Addendum to the  
Environmental Impact  
Assessment Report

**NISA**  
*North Irish Sea Array*

Volume 3 - Offshore Chapters

# Chapter 10

**Graph A10.2 Variations in near-shore wave heights (replaces Graph 10.5 of Chapter 10 of the 2024 EIAR)**

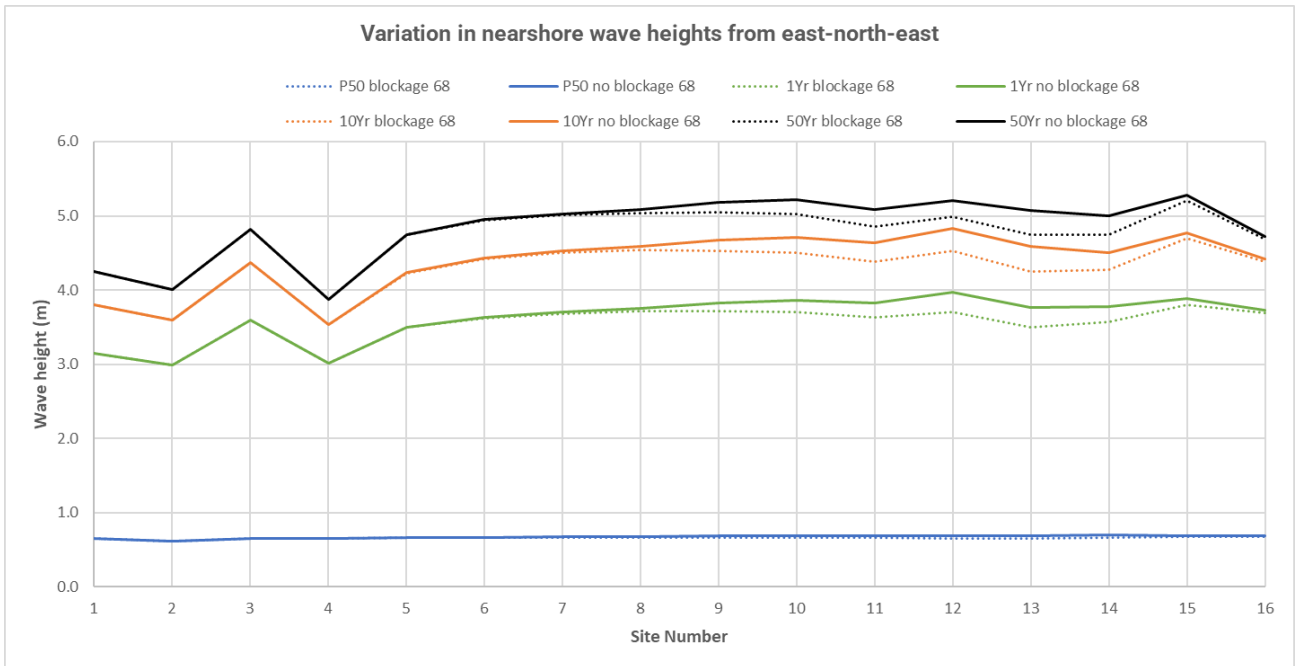
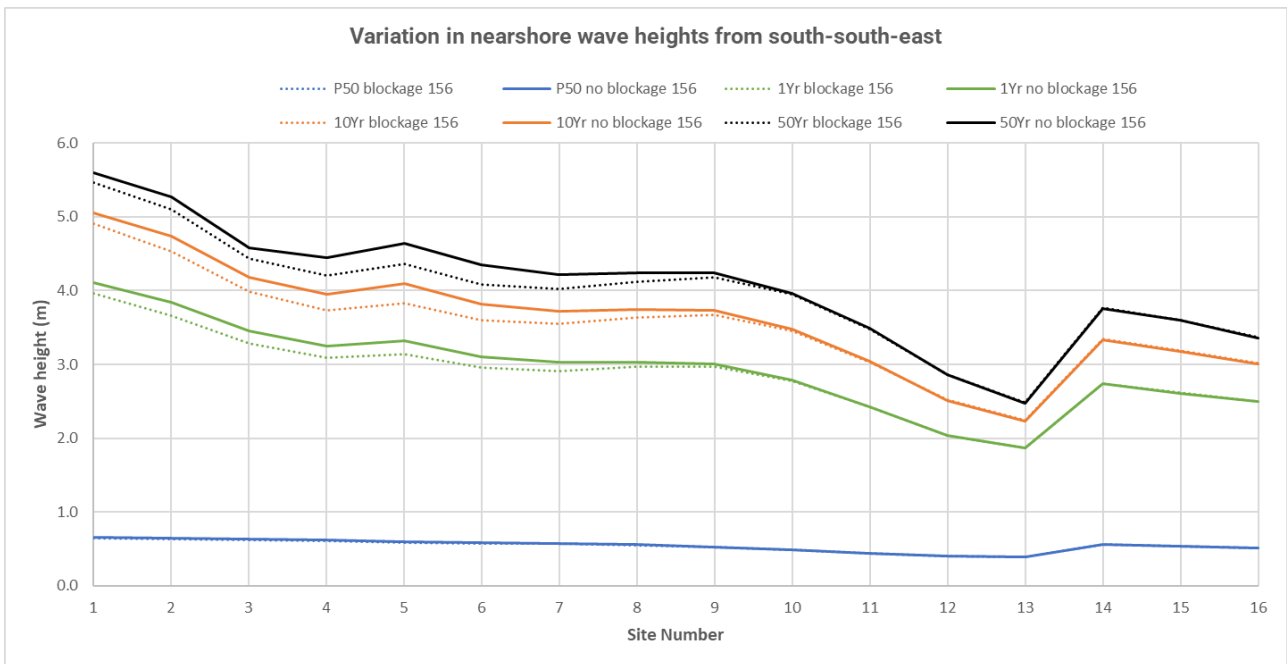
**Graph 10.5 and Graph 10.6 of Chapter 10 of the 2024 EIAR have been updated based on the revised modelling (Appendix A10.2). Therefore, Graph 10.5 and Graph 10.6 of Chapter 10 of the 2024 EIAR shall be removed and replaced with Graph A10.2 and Graph A10.3 respectively. “Sensitivity of the receptor” in Section 10.5.3.4 of Chapter 10 of the 2024 EIAR has been removed and replaced with the following text;**

Graph A10.2 – Part 1 presents changes in nearshore waves from east-north-east. The P50 wave condition shows very little change in wave heights in the nearshore with the largest local reduction of up to 0.03m (Site 13 – south of the ECC) relative to a baseline of 0.69m (or 5.0% reduction). In comparison, the 1 in 1 year return period shows a reduction up to 0.27m relative to a baseline of 3.76m (or a 7.2% reduction) for the same site. The 1 in 10-year event shows a reduction of up to 0.34m relative to a baseline of 4.59m (or a 7.4% reduction), and the 1 in 50-year event shows a reduction of up to 0.32m relative to a baseline of 5.07m (or a 6.4% reduction).

Graph A10.2 – Part 2 presents changes in nearshore waves from the prevailing south-south-east direction. The P50 wave condition also shows very little change in wave heights in the nearshore with the largest local reduction of up to 0.01m (Site 5 – off Clougher Head) relative to a baseline of 0.60m (or 1.8% reduction). In comparison, the 1 in 1 year return period shows a reduction up to 0.18m relative to a baseline of 3.32m (or a 5.3% reduction) for the same site. The 1 in 10-year event shows a reduction of up to 0.26m relative to a baseline of 4.10m (or a 6.5% reduction), and the 1 in 50-year event shows a reduction of up to 0.29m relative to a baseline of 4.64m (or a 6.2% reduction).

**Graph A10.3 Variation in wave heights from offshore to near-shore for south-south-east wave direction (replaces Graph 10.6 of Chapter 10 of the 2024 EIAR)**

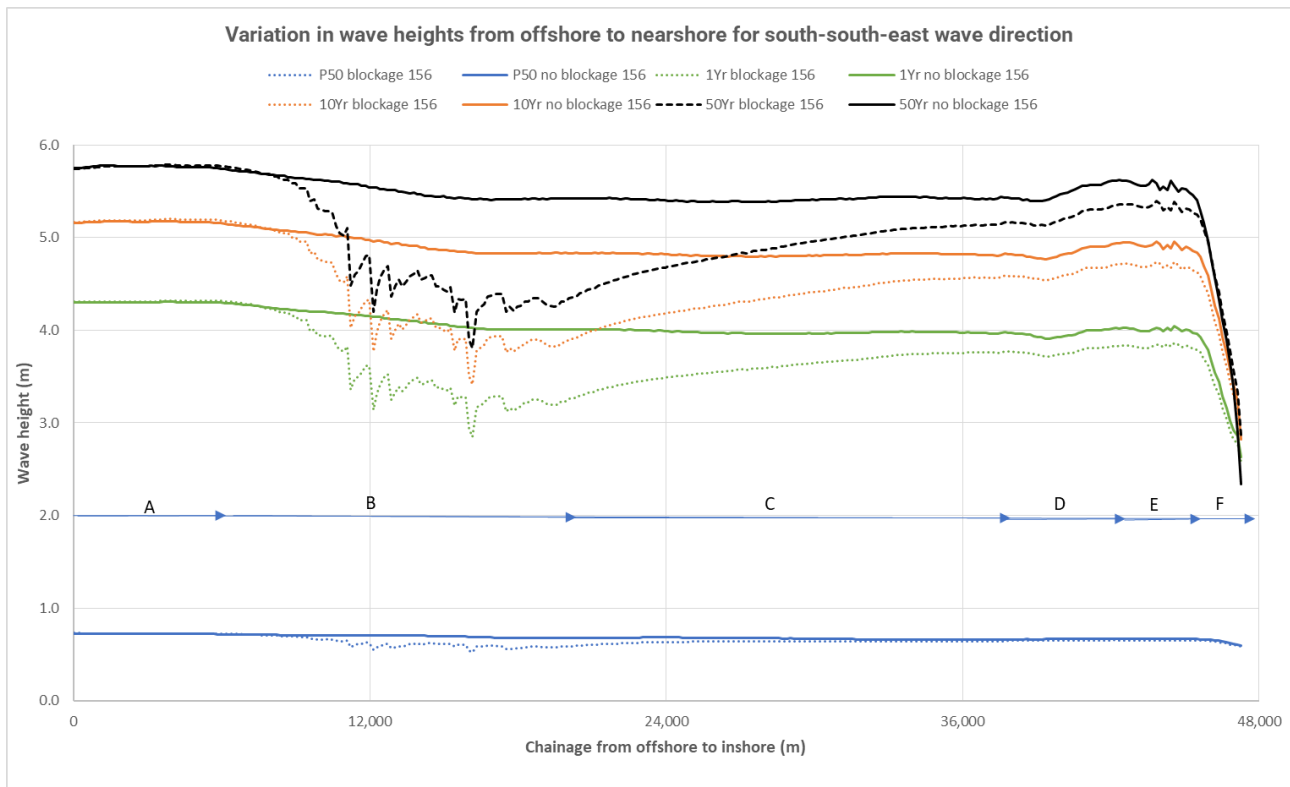
Graph A10.2 offers a further presentation of predicted reductions in wave heights for the prevailing south-south-east wave direction for all wave return periods and for a transect from offshore (upwind of the array area) to the coastline near Ballagan Point. Six zones are identified:
